05V-067
(18 pages)

Regarding: Yamaha XV250, XVS65 and XVS11 model Passenger Seat Mounting Hardware Factory Modification Campaign

All XVS11A, XVS11AT, XVS11, XVS65A, XVS65AT, XVS65, and XV250 FACTORY MODIFICATION CAMPAIGN

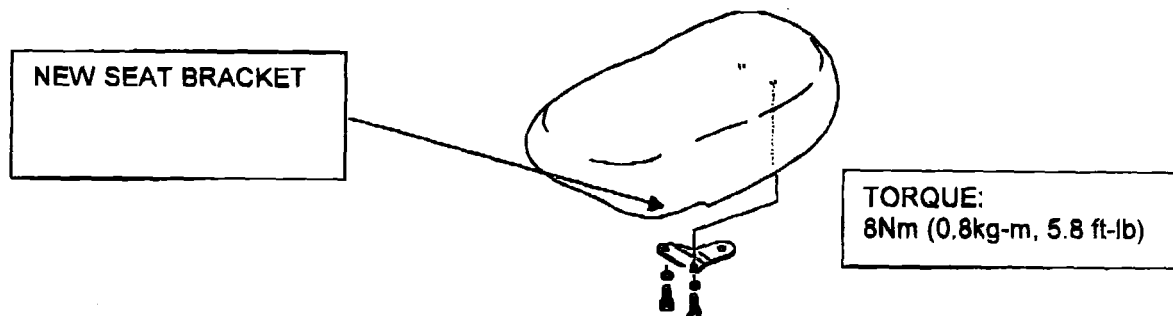
2. Unscrew the two mounting bolts for the passenger-seat bracket, and then remove the seat mounting bracket from the passenger seat. Save the two mounting bolts and washers for reuse. Hold the original bracket for 90 days with a Warranty Parts Tag.

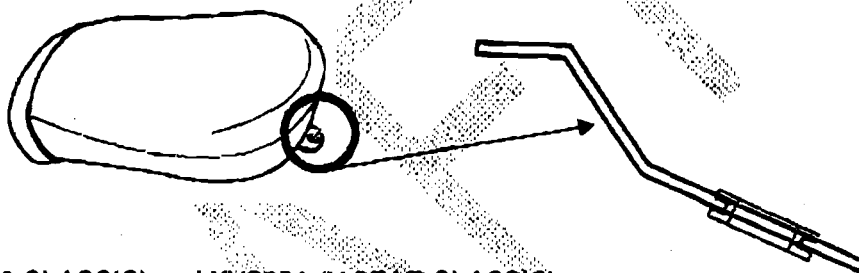
3. Install the new seat bracket from the kit using the original bolts and washers. The new bracket has a larger hole for the grommet.

4. Install the new grommet from the kit in the bracket hole. Continue to the appropriate instructions for the model being modified.

ASSEMBLED LENGTH

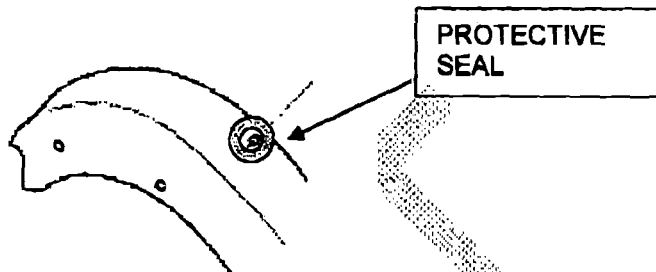
2. Hold the stud bolt from the kit at the unthreaded portion. Screw the cap nut onto the end of the stud with the longer threads until the exposed stud is 19mm long.

- The cap nut is a self-locking type. The assembled stud length is important to allow the locking tab in the cap nut to be properly engaged.
 - Be sure the cap nut is installed on the end of the stud with the longer threaded portion.
3. Be sure the painted area around the stud hole is clean, then remove the backing and apply the new protective seal from the kit to the rear fender.

APPLY LOCTITE TO THE
STUD THREADS

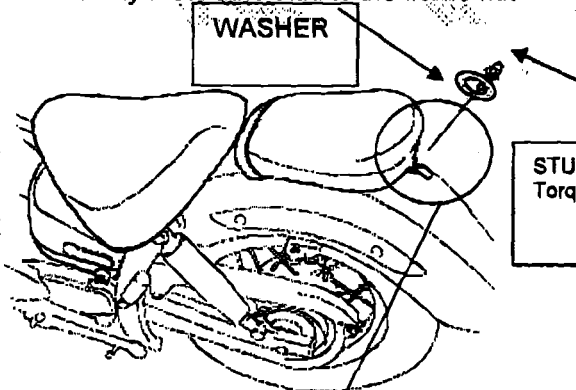
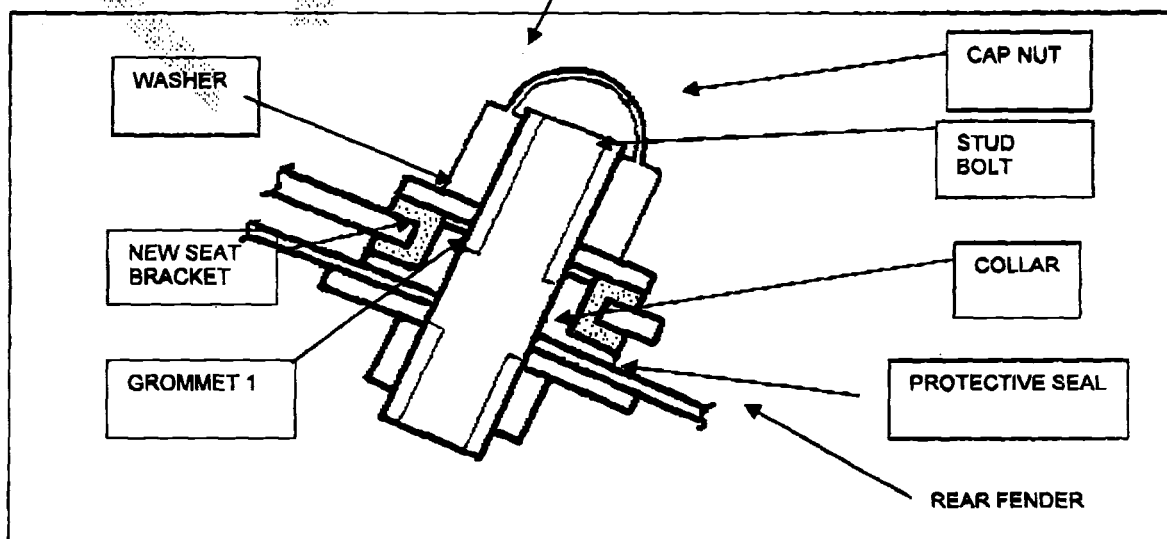
4. Place the passenger seat on the rear fender, making sure the collar is in place in the grommet. Place the new washer from the kit over the grommet. Apply Loctite® 648 or 271 to the shorter threads of the stud bolt (the end opposite the cap nut). Install and tighten the stud bolt with the cap nut.

The Loctite® is used to permanently mount the stud to the frame nut.

STUD BOLT WITH CAP NUT
Torque: 25Nm (2.5 m·kg, 18 ft·lb)

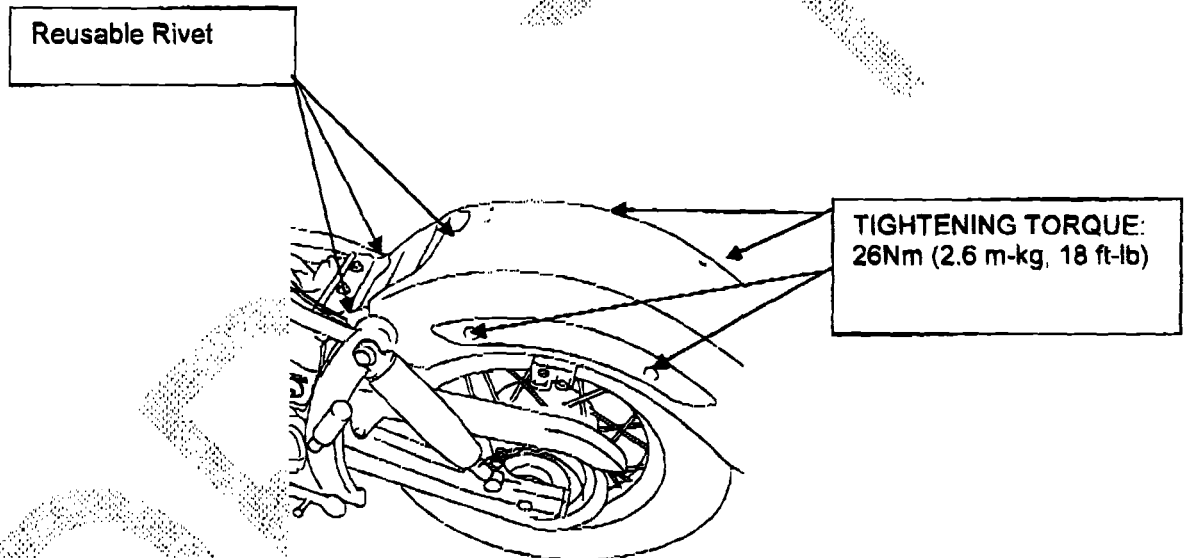
On this model, the hole in the rear fender for the passenger seat's mounting stud must be enlarged to fit the new fastener from the kit.

3. Lift the rear fender just enough to access the stud hole. Using a step drill another appropriate tool, carefully enlarge hole on the rear fender for the passenger seat stud bolt to 13.5mm. Smooth the edges of the hole.
4. Be sure the painted area around the stud hole is clean, then remove the backing and apply the new protective seal from the kit to the rear fender.

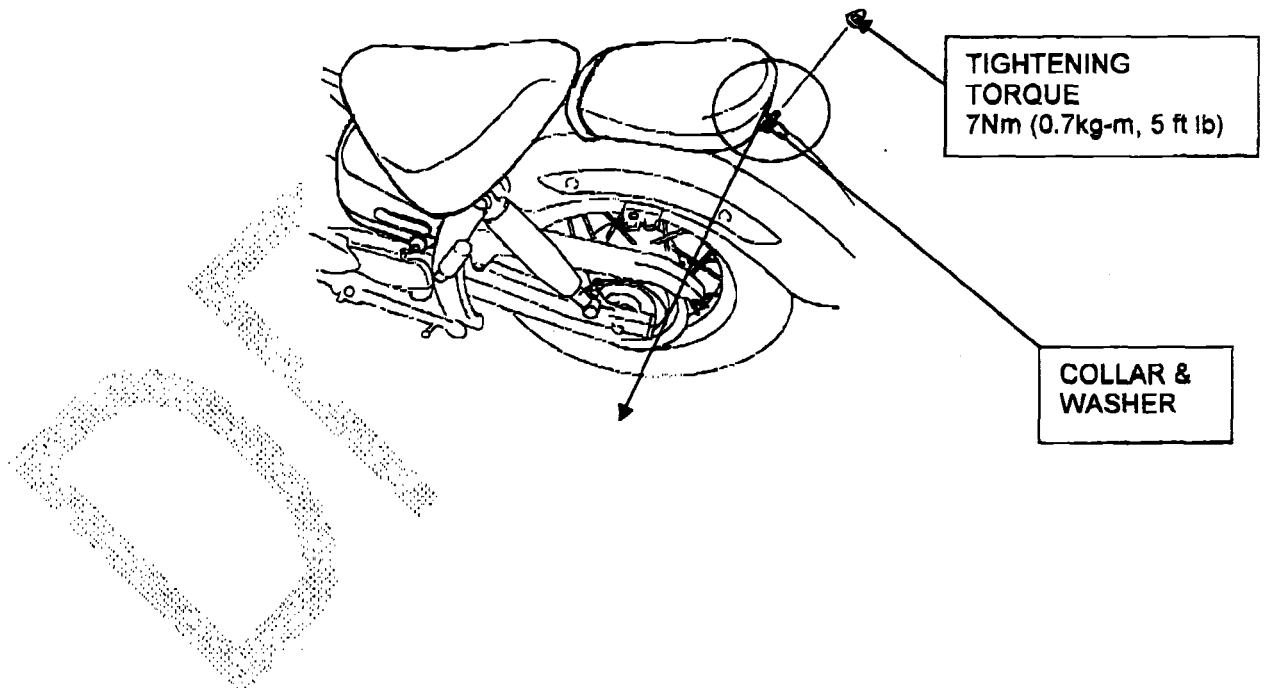
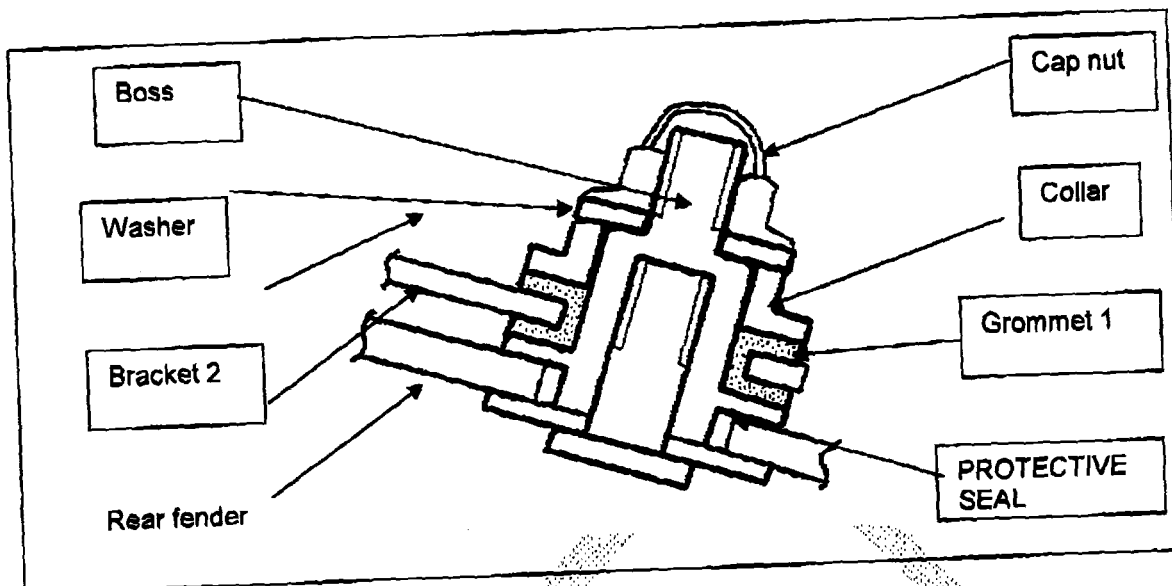
7. Apply Loctite® 648 or 271 (red type) to the mounting stud for the passenger seat. Install the new boss from the kit on the original stud. Tighten the boss to specification.

The Loctite® is used to permanently mount to boss to the stud.

8. Place the passenger seat on the rear fender. Place the collar and washer on the grommet and tighten the cap nut to specification.

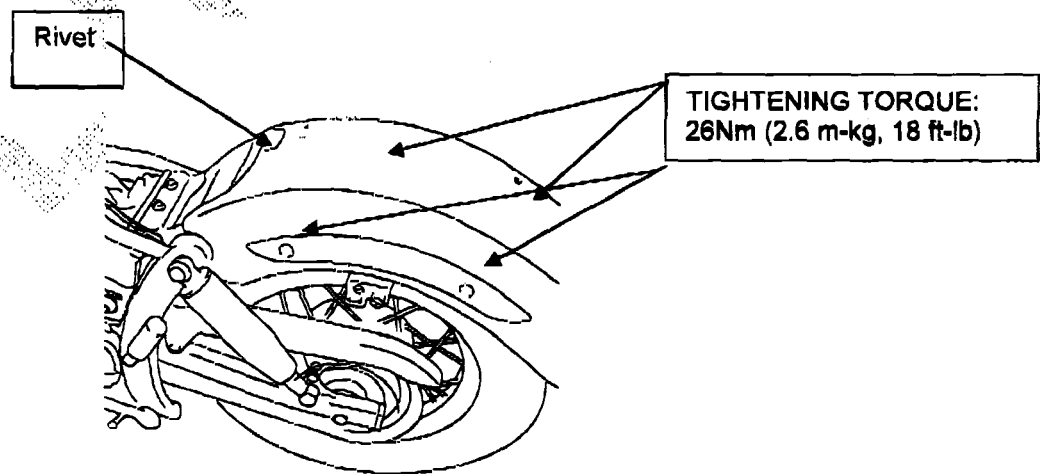
3. Lift the rear fender just enough to have enough space to remove original grommet. Install the new grommet 3 between rear fender and rear frame through the stud hole.

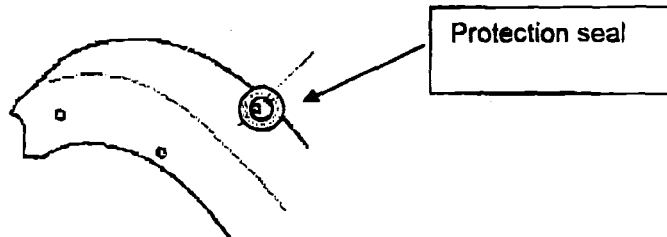
2. Use the shorter bolt from the kit (the 51mm stud is for other markets where a rear seat stay is installed as standard equipment). Hold the stud bolt (stud bolt-1) from the kit at the unthreaded portion. Screw the cap nut onto the end of the stud with the longer threads until the exposed stud is 19mm long.

- The cap nut is a self-locking type. The assembled stud length is important to allow the locking tab in the cap nut to be properly engaged.
 - Be sure the cap nut is installed on the end of the stud with the longer threaded portion.
3. Be sure the painted area around the stud hole is clean, then remove the backing and apply the new protective seal from the kit to the rear fender.

APPLY LOCTITE TO THE
STUD THREADS

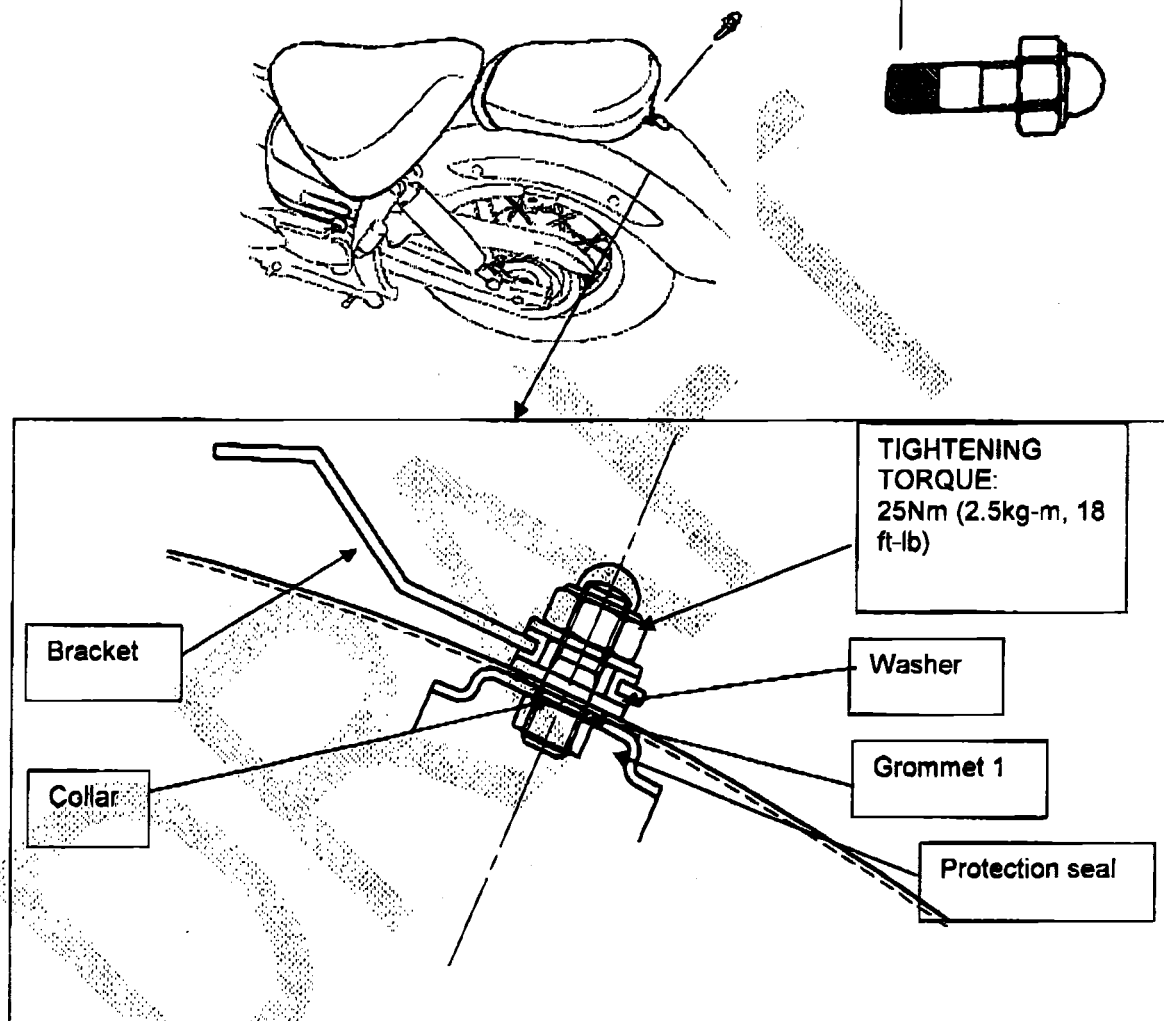
4. Place the passenger seat on the rear fender, making sure the collar is in place in the grommet. Place the new washer from the kit over the grommet. Apply Loctite® 648 or 271 to the shorter threads of the stud bolt (the end opposite the cap nut). Install the stud bolt with the cap nut and tighten to specification.

The Loctite® is used to permanently mount the stud to the frame.
